RE: Supplemental Recommendations to Geotechnical Engineering Report

Phase I Residential Development at the Pines

Terracon Project No. 63045225, Addendum 10, Revision 1

FIG. No.

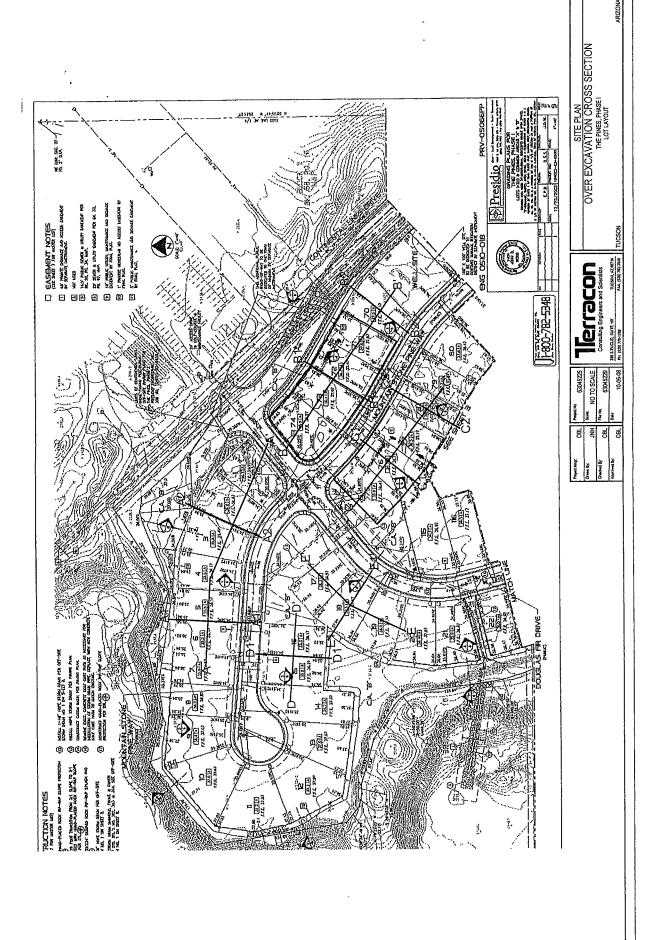
The attached Figures 1 through 6 show these areas and cross sections of our recommended overexcavation zones. Soils overexcavated and recompacted as engineered fill should be placed in loose lifts not exceeding 12-inches in height, and should be compacted to a minimum of 95 percent of Standard Proctor Density (ASTM D698) near optimum moisture content.

The cross sections indicate access ramps down into each of the excavations with inclinations of about 3.5:1 (horizontal:vertical). These slopes would not need to extend across the entire side of a given excavation, but rather be wide enough to accommodate the excavation equipment. The remainder of that side of the excavation may have slopes as steep as 1:1 (horizontal:vertical). Also, we understand some of the ramps as shown on our cross section may need to be relocated to other portions of the excavations due to existing site walls.

Area	Depth From Existing Grade (ft)
Lots 1 - 4	10
Lots 5 and 6	5
Lot 70	10
Lots 71 - 74	15
Lot 78	10
Lots 75 - 77	15
Lots 15 and 16	5
Lots 17 - 19	10
